PCN-274984
Product Change Notice

Issue Date: 1-February-2024

PCB change for ChipLED part numbers listed below

Existing	New

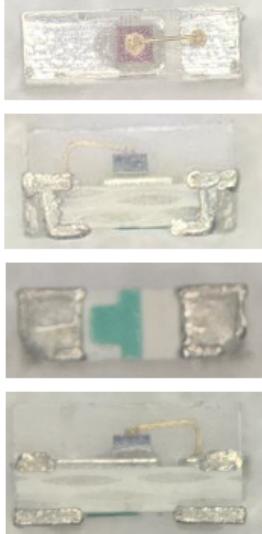
There is a change of form and function but no change in fit, quality and reliability. The new and existing PCB appearance as per below:

A new PCB will replace the existing PCB used in the part numbers listed above. This new PCB is qualified as per Broadcom's qualification process

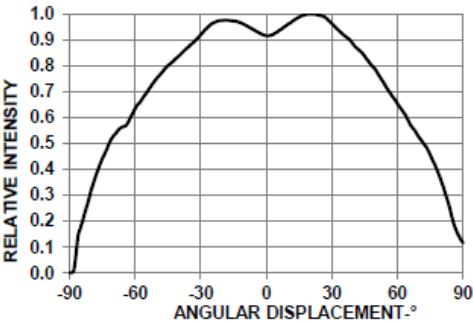
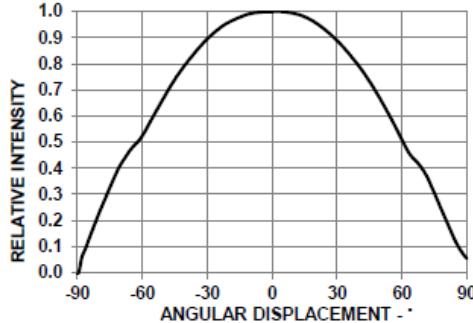
Radiation Pattern & Typical Viewing Angle Note: Only applicable for AlInGaP parts (HSMC/HSMA/HSML/HSME). No Change for InGaN parts (HSMR/HSMW/HSMQ) <div style="text-align: center;">  <p>Typical Viewing Angle, $2\theta_{1/2} = 140^\circ$</p> </div>	Radiation Pattern & Typical Viewing Angle Note: Only applicable for AlInGaP parts (HSMC/HSMA/HSML/HSME). No Change for InGaN parts (HSMR/HSMW/HSMQ) <div style="text-align: center;">  <p>Typical Viewing Angle, $2\theta_{1/2} = 120^\circ$</p> </div>
